**CITY OF ROCKVILLE
HISTORIC DISTRICT COMMISSION
STAFF REPORT
For
February 18, 2010 Meeting No. 02-2010**

APPLICATION: HDC2010-00494
ADDRESS: 8 Thomas Street
ACCEPTED: January 25, 2010
45-DAY LIMIT: March 19, 2010
OWNERS: Alex and Rebecca
Daskalakis
REQUEST: Rear Screened Porch
STAFF: Robin D. Ziek

REQUEST SUMMARY: The proposed project is for rear screened porch addition to a two-story single-family house. The total added living area is 256 sf.

Proposed Site Plan

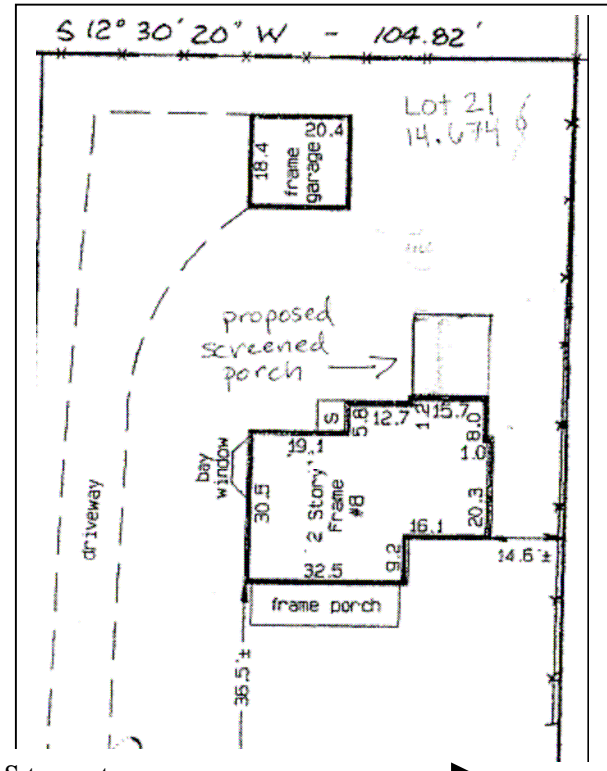
Siting: The new porch will sit in the rear yard, and is designed as an extension of the existing one-story addition off of the family room. This existing addition has served as a back hall, and links the family room to the main part of the house, while providing egress to the backyard.

Design: The rear screened porch addition will measure 16' x 16' (256 sf) and be constructed at the rear of the house, at the southeast corner. The one-story porch will have a front gable roof that attaches to an existing roof below the existing eaves. The screened porch is designed as an extension of the existing 1993 rear addition. The lower 2'-6" of the porch "wall" will be enclosed, leaving the rest of the "wall" area with screening. A rear door from the screened porch provides egress on the north side, leading to the driveway.

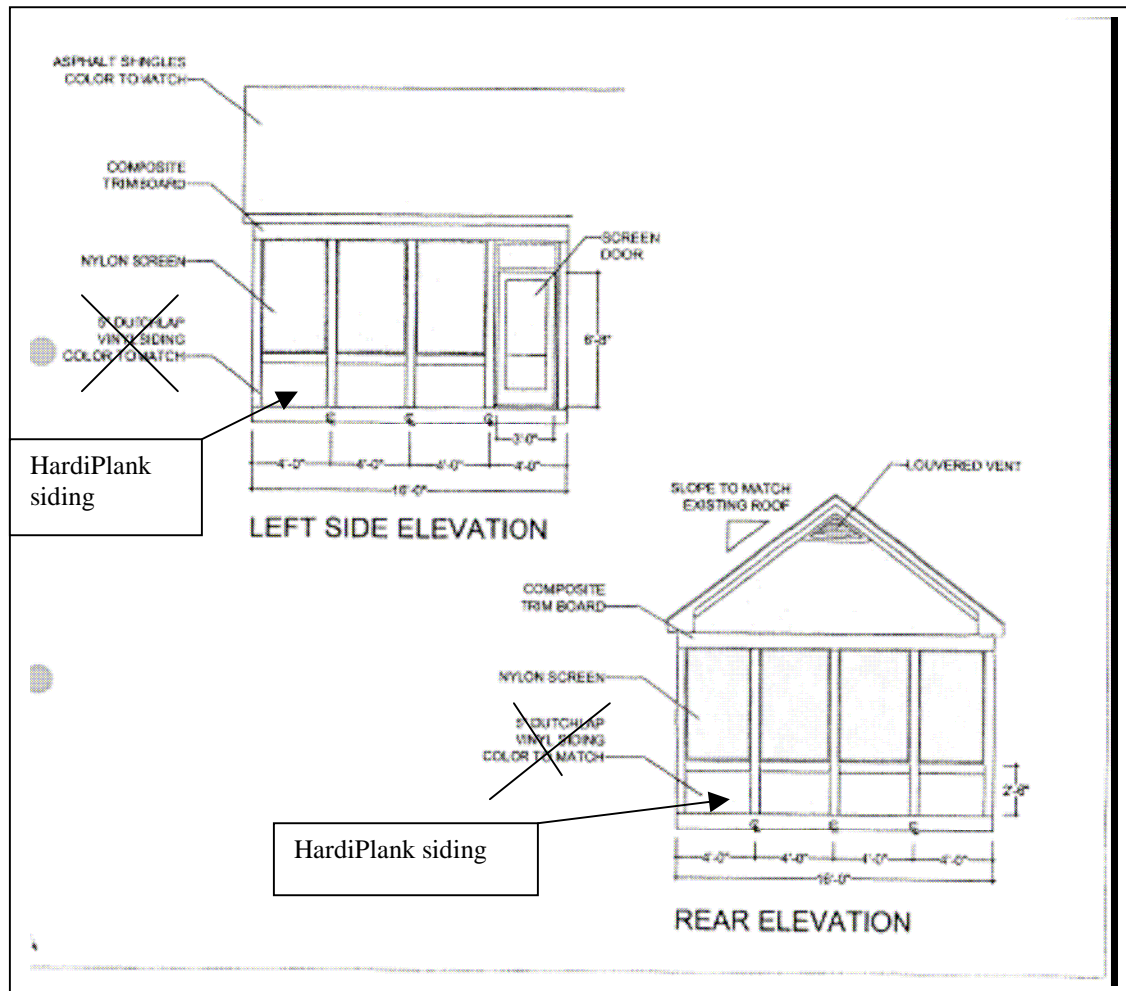
Materials: The existing rear addition has metal shingles on it, matching the main roof of the house. The new porch roof is proposed to have asphalt shingles. The owner could not locate metal shingles that exactly matched the existing roof shingles, and decided to match the color of the existing roof. Composite wood material is proposed for all trim pieces. Vinyl siding was initially proposed for the lower 2-1/2 feet of "wall" and also for the gable end, but the owner has agreed to install HardiPlank fiber-cement board after discussions with staff and his contractor.

Foundation Construction: The porch will utilize post-and-beam construction to minimize root disturbance to the mature poplar in the back yard. In addition, this will allow aeration of the

surface roots in this vicinity and permit surface water to drain across the porch site to the extent that it can on this flat rear yard.

Conditions: 1. The HardiPlank clapboard shall have a smooth “wood” finish.
